NPRR 140

DC Energy Comments

September 16, 2008

DC ENERGY
QUANTITATIVE TRADING

Zero Price Bids – Credit Requirements –

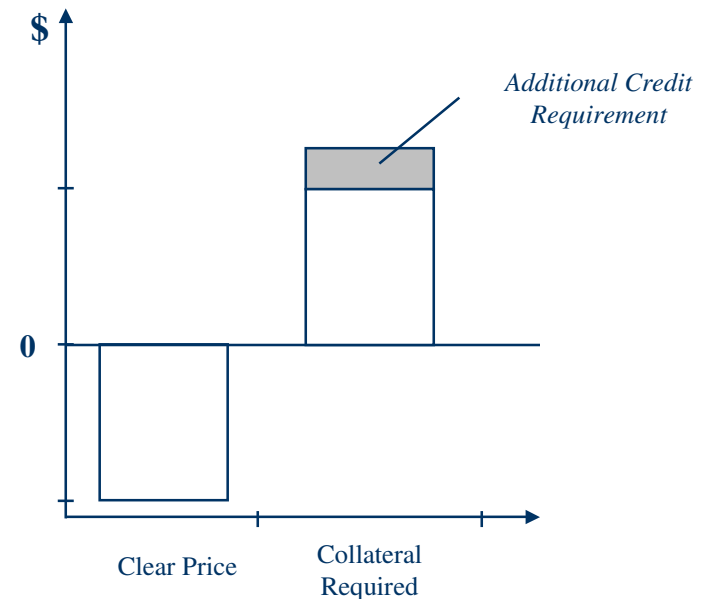
Collateralizing negative bids does not provide protection to the market because a participant can circumvent that requirement by offering at zero or positive.

A participant offering its CRRs at zero, will not have to post any bid price based credit. Thus, demanding it from other participant unnecessarily penalizes participants willing to bid at true value.
